REVISED RESPONSE TO REQUEST FOR ADDITIONAL INFORMATION

APR1400 Design Certification

Docket No. 52-046

RAI No.: 356-7881
SRP Section: 07 – Instrumentation and Controls – Overview of Review Process
Application Section: 7.0
Date of RAI Issue: 01/04/2016

Figure 7.7-14 I&C System Architecture for the RCC Panel

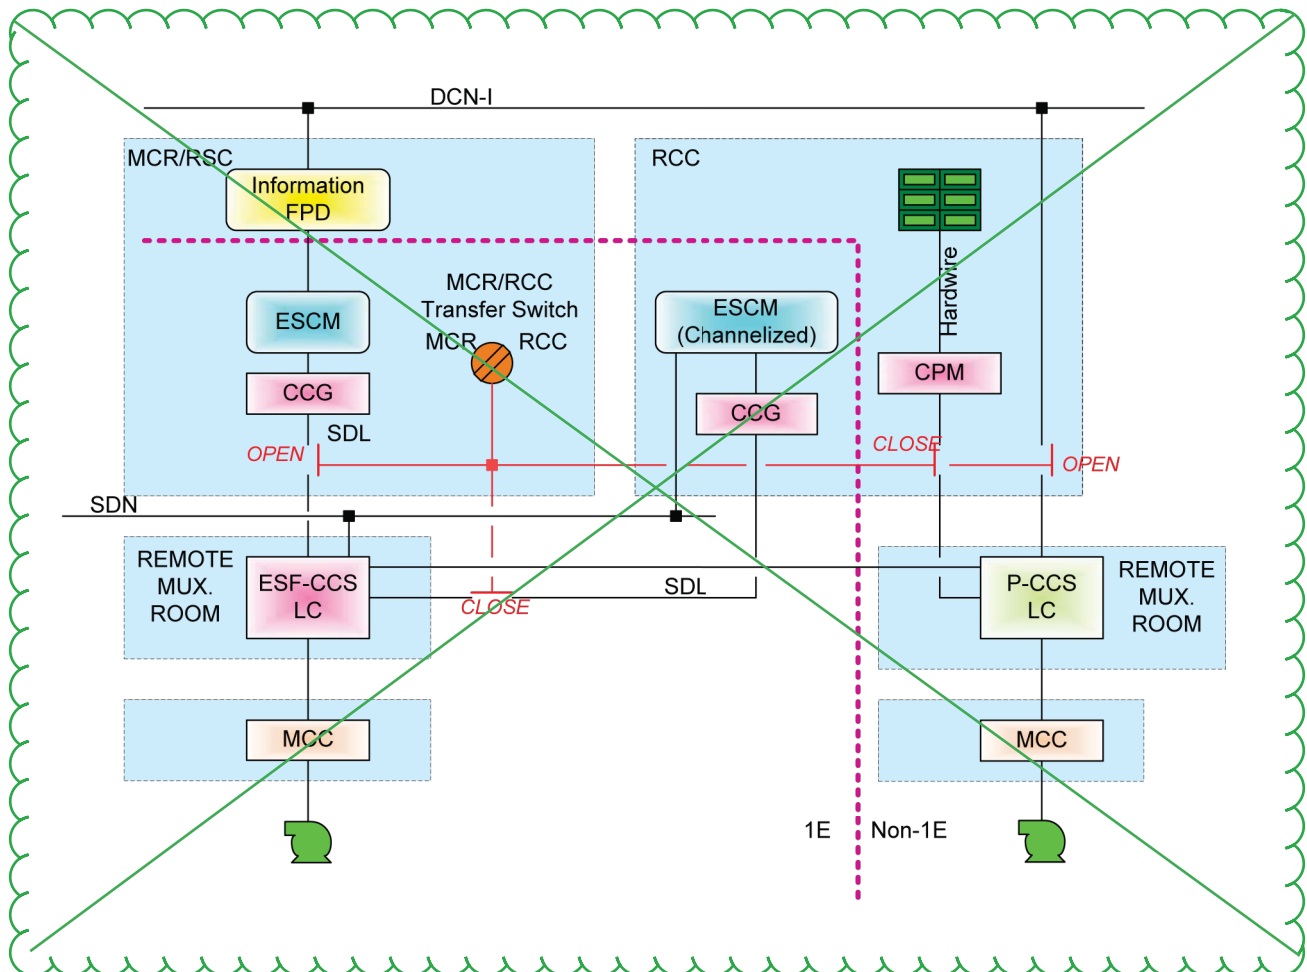
DCD Tier 2, Section 7.0, Section 7.7.1.1, Figure 7.1-1, APR1400-Z-J-NR-14001-P/NP, Rev. 0, "Safety I&C System," Figure 4-1, and APR1400-Z-J-NR-14002-P/NP, Rev. 0, "Diversity and Defense in Depth," Figure 4-1 will be revised. The depiction of the I&C architecture of the RCC will be added as Figure 7.7-14. DCD Tier 1, Section 2.5.4.1 will be revised to show that the ESCMs on the MCR, RSR, and RCC have same design features, as indicated in the attachment associated with this response.

- The I&C system architecture for the RCC panel is shown in Figure 7.7-14.

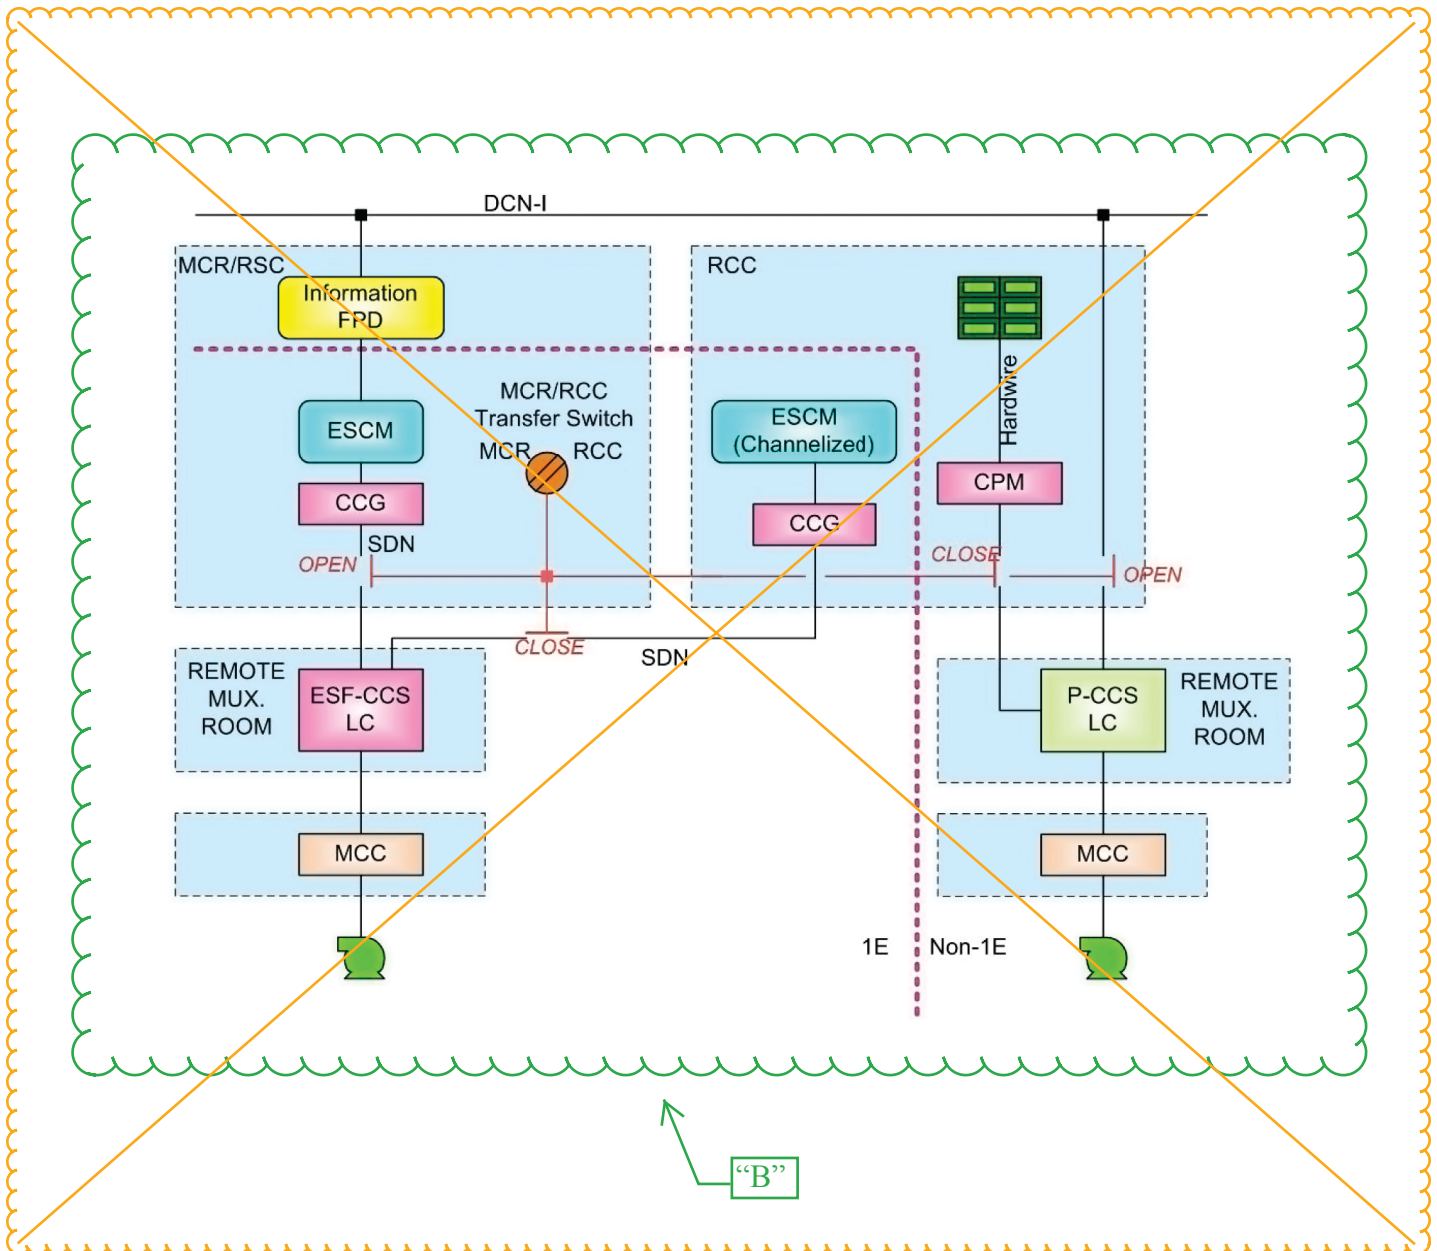
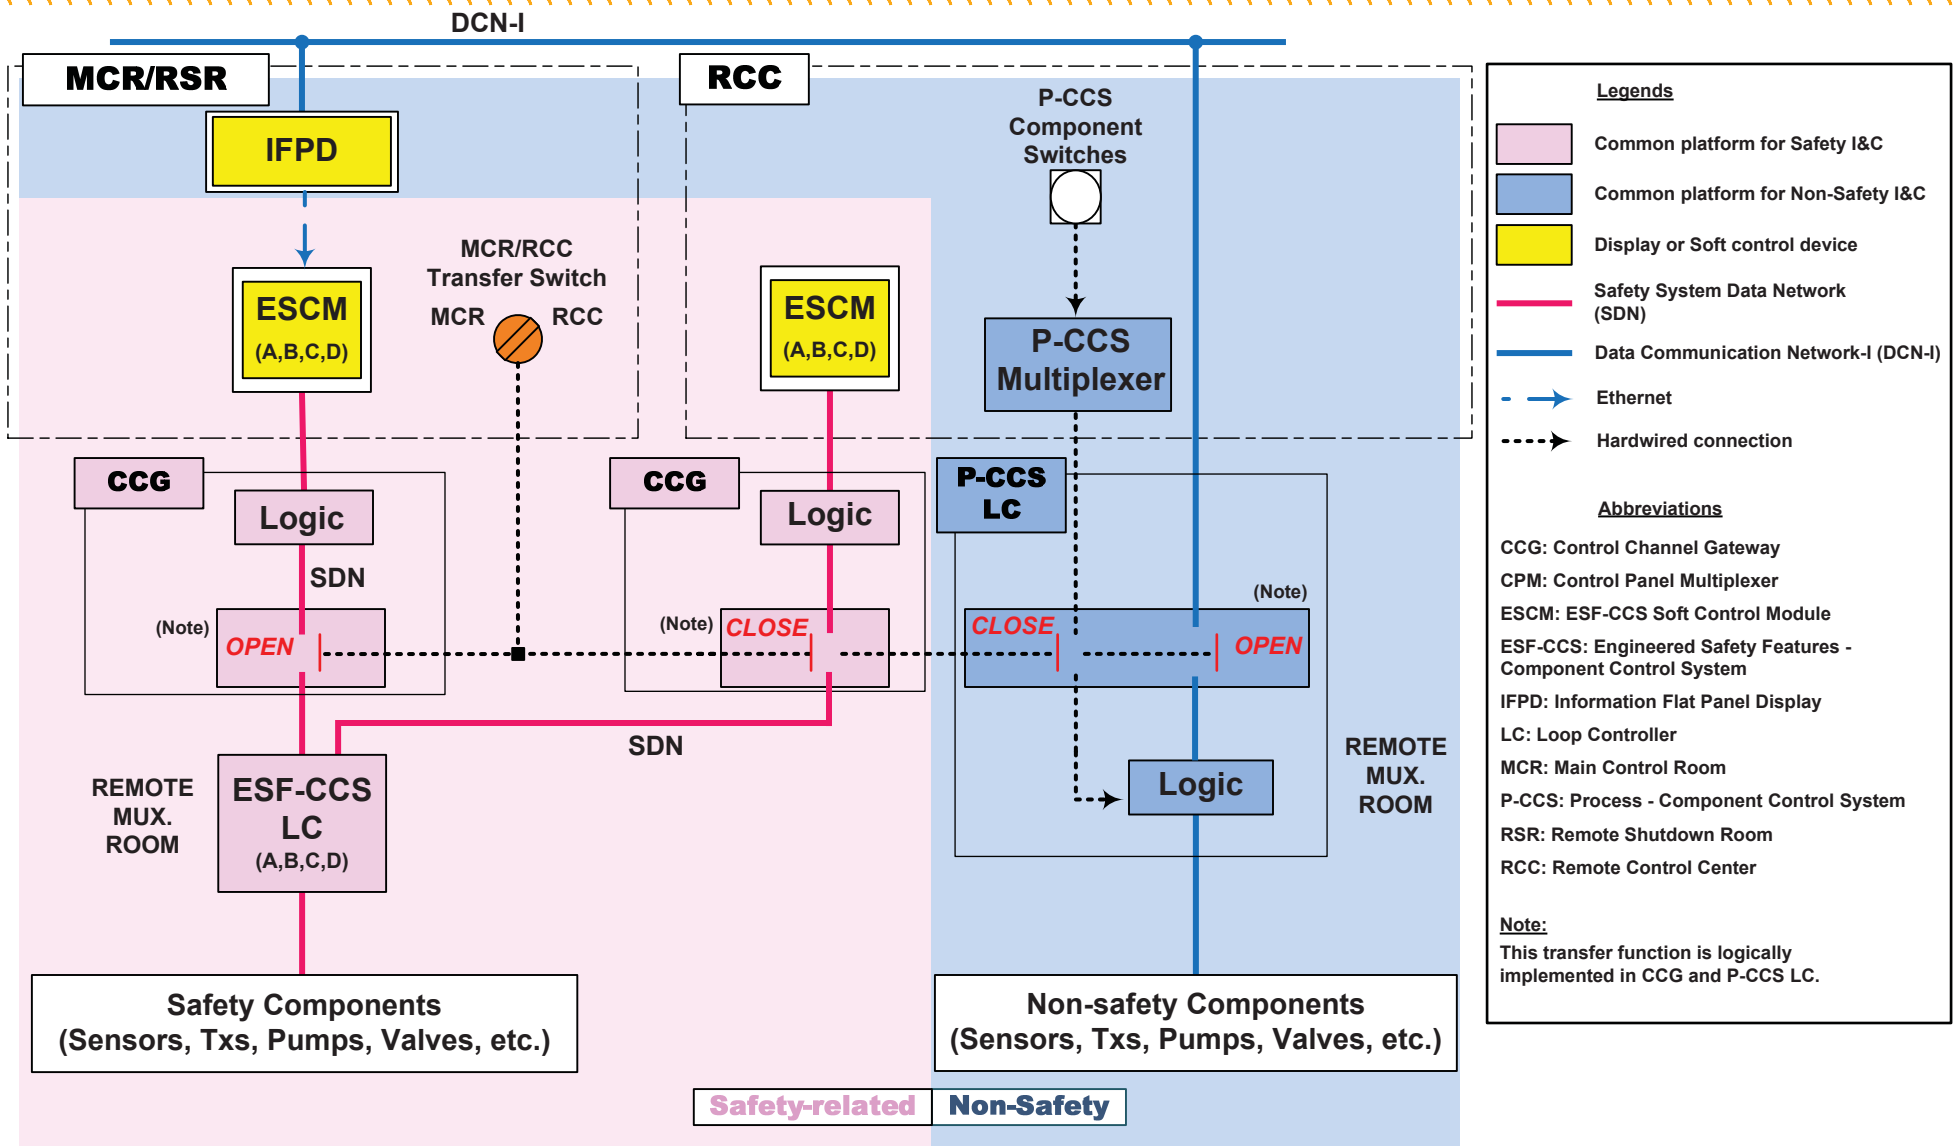
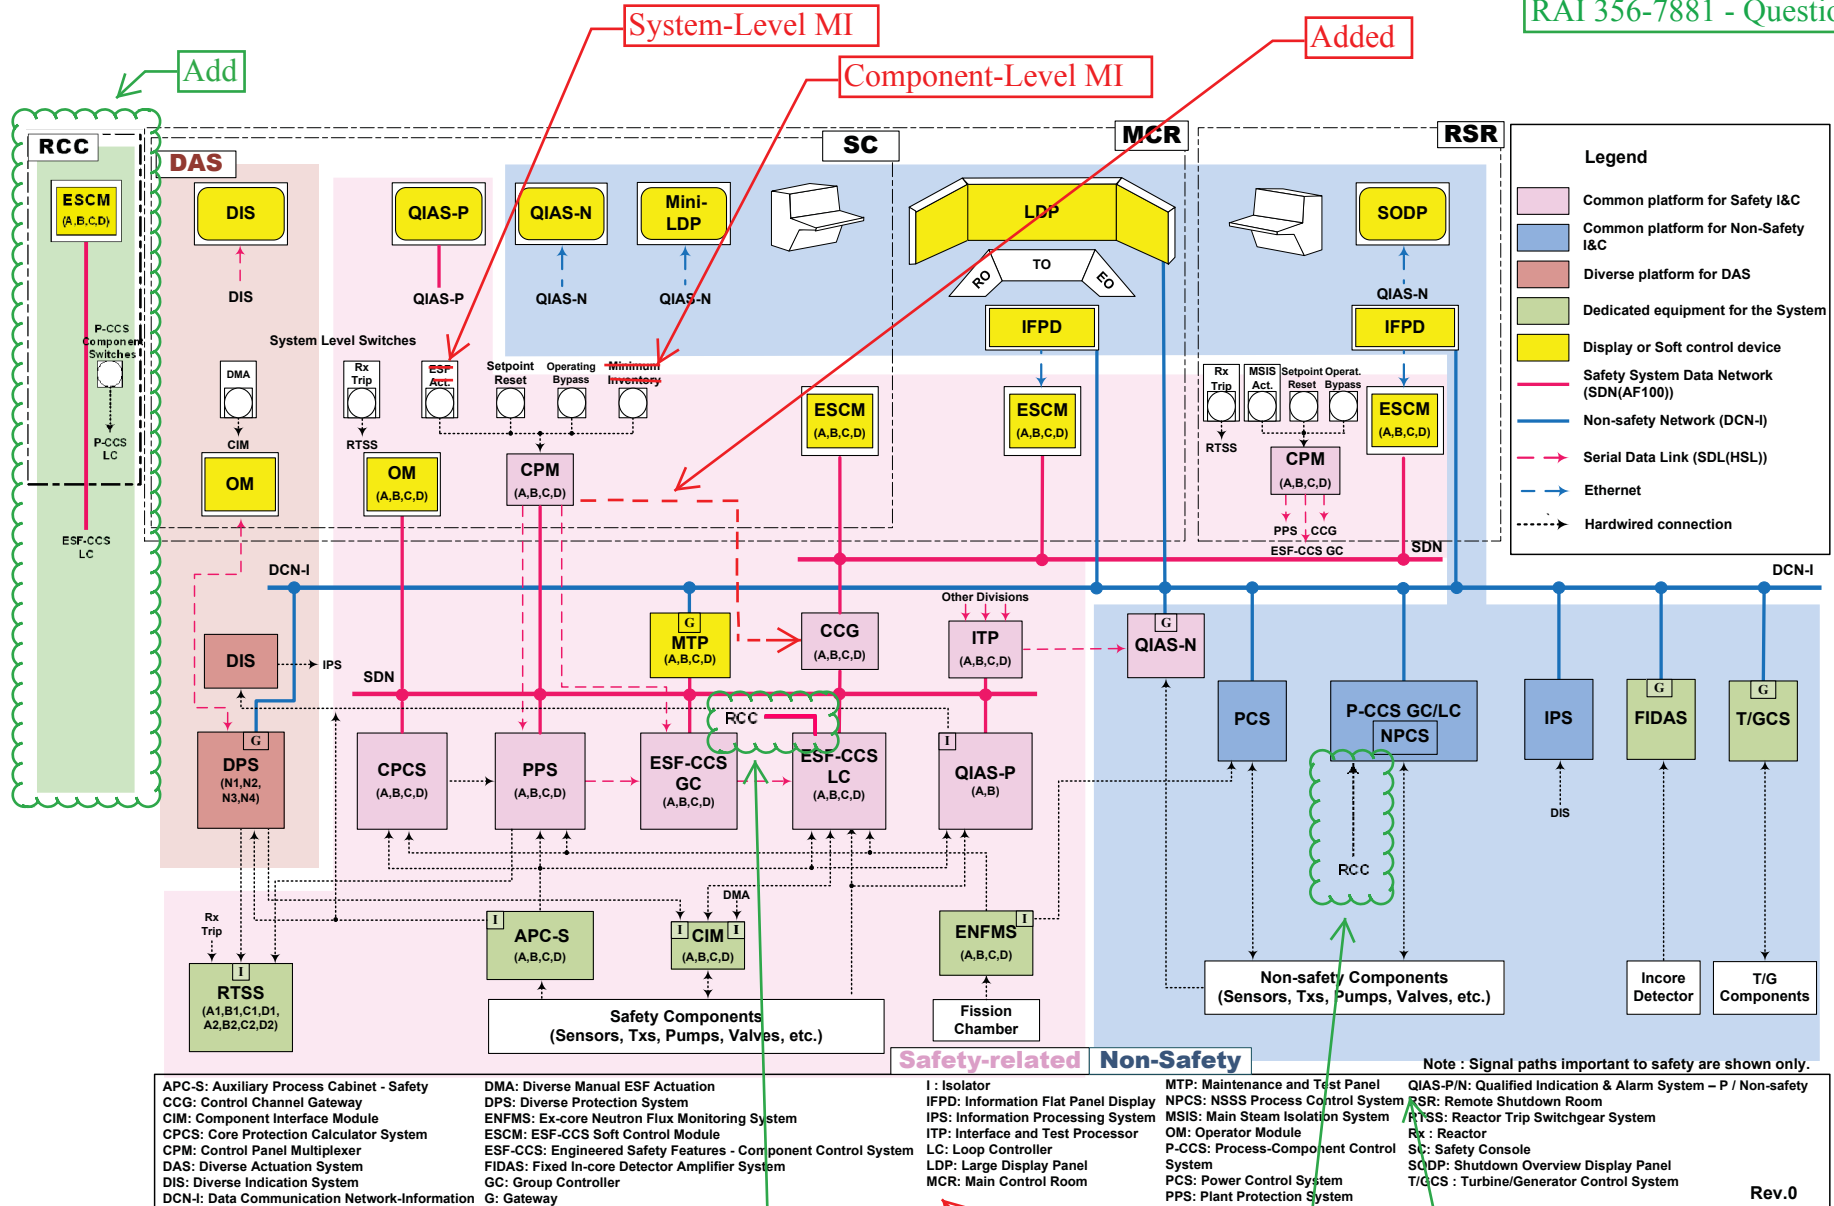
The applicant mentions that the RCC has safety and non-safety related controls available but does not state that RCC complies with any other applicable requirements for this configuration such as independence. The RCC is not depicted on Figure 7.1-1, "APR1400 I&C System Overview Architecture," therefore, there is no physical depiction of how the functionality of the RCC is taken into account within the overall I&C architecture or how its implemented. The acronym for the remote control center is also not defined in the acronym and abbreviation list in Section 7.0 of FSAR Tier 2. It cannot be determined what the difference is between the RCC and RSR.

Replace with "B" on following page

"B"

Figure 4-1 Architecture Overview of the APR1400 I&C Systems

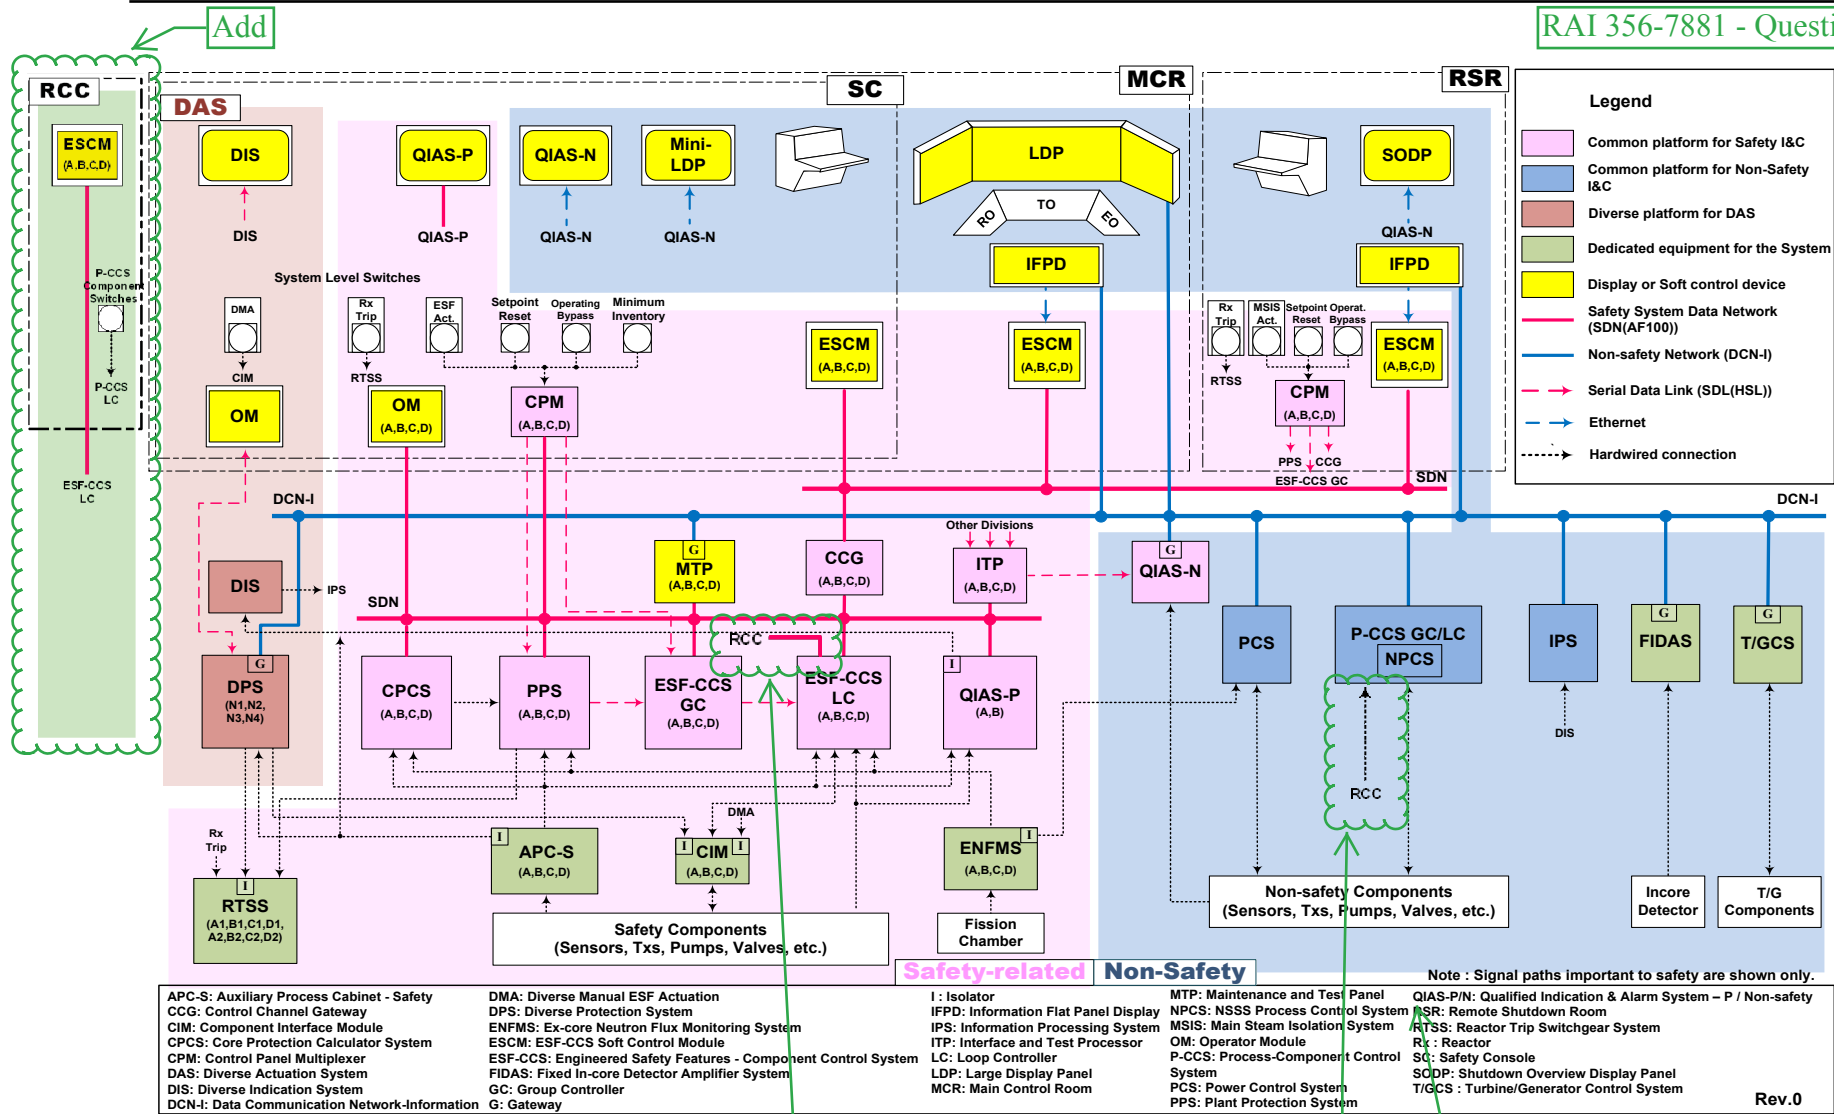
APR1400-Z-J-NR-14001-P/NP, Rev. 0, "Safety I&C System," Figure 4-1, and APR1400-Z-J-NR-14002-P/NP, Rev. 0, "Diversity and Defense in Depth," Figure 4-1 will be revised as indicated in the attachment associated with this response.

RCC : Remote Control Center
